BULLETIN NUMBER:
CB15-X-001

VOLUNTARY EMISSION RECALL INCORRECT VIN AND WEIGHT RATING/GHG LABEL #V1502

- 2015MY Isuzu NPR Vehicles (See Attached VIN List)
Equipped with 3.0L (4JJ1) Diesel Engines

Figure 1

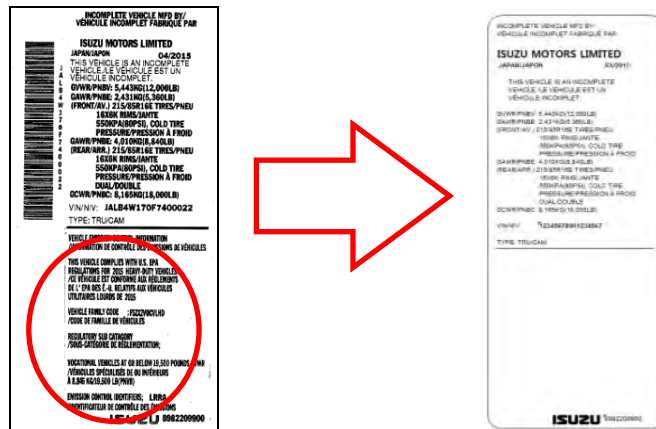
- 1) Verify new and old labels have matching VIN numbers. Note that the correct VIN and Weight Rating label will not include the GHG information on the lower half of the label titled, "Vehicle Emission Control Information" (Figure 1).

Figure 3a

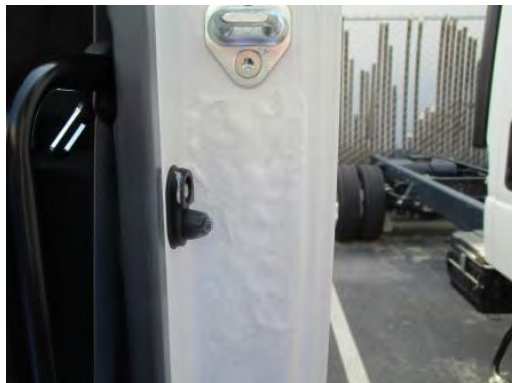
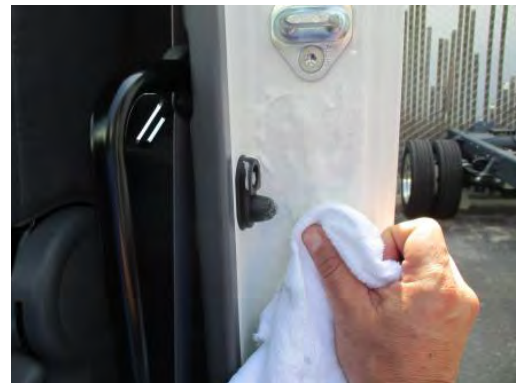
- Remove old label glue residue by applying a light coat of CRC™ gasket remover (Figure 3a) and letting it soak for no more than two (2) minutes before wiping it off with a clean cloth (Figure 3b).

Figure 4

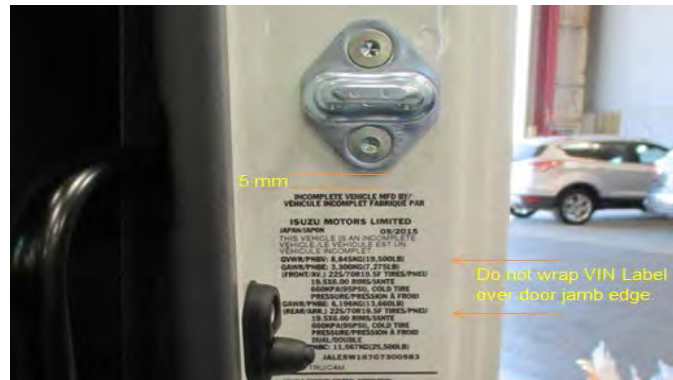
- 4) Apply new VIN and Weight Rating label in area shown (Figure 4), located **5mm below striker** in driver's door jamb. Be careful **not to wrap label over door jamb edge**.

Figure 9

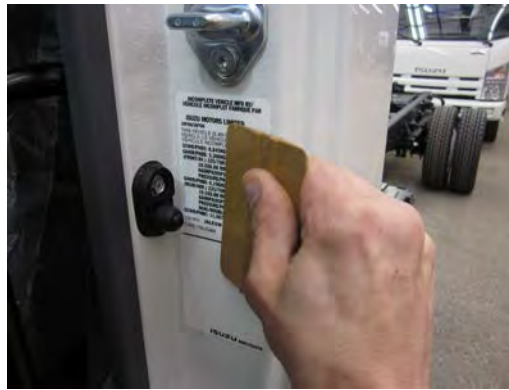
- 9) Peel the second half of the film backing, apply water/soap solution to protective film as needed and remove excess with 3M™ Scotchcal™ application squeegee (Figure 9).
